TO: Mercedes-Benz Dealer Principals, General Managers,	FROM: Gregory Gunther, Senior Manager, Vehicle	
Sales Managers, Service Managers, Parts Managers	Compliance and Analysis, Engineering Services	
RE: Service Campaign Launch Notification		
Retrofit Headlamp Housing Screws	DATE: January 19, 2024	
MY22 SL (232 platform)

Service Campaign Bulletin

Campaign No. 2023120019, January 2024

Retrofit Headlamp Housing Screws

Figure 2

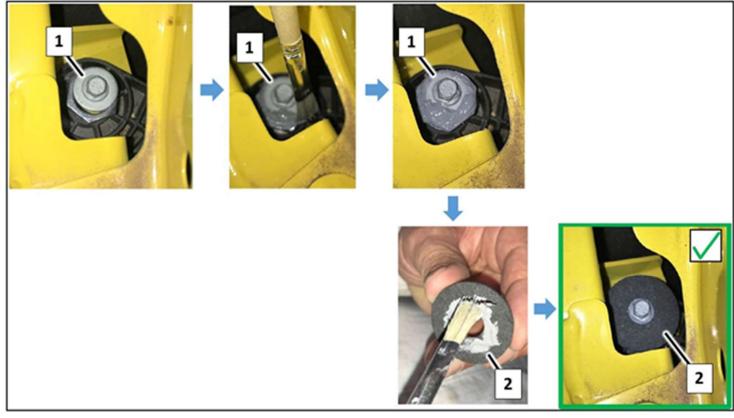
2. Coat washer (1, Figure 2) on left and right headlamp housing screws and felt (2, Figure 2) with windshield adhesive.

i The entire contact surface must be coated with windshield adhesive.

- 3. Glue felt (2, Figure 2) onto washer (1, Figure 2) of left and right headlamp housing screws so that it is flush.
- 4. Remove any excess adhesive with a lint-free cloth and suitable cleaning agent.
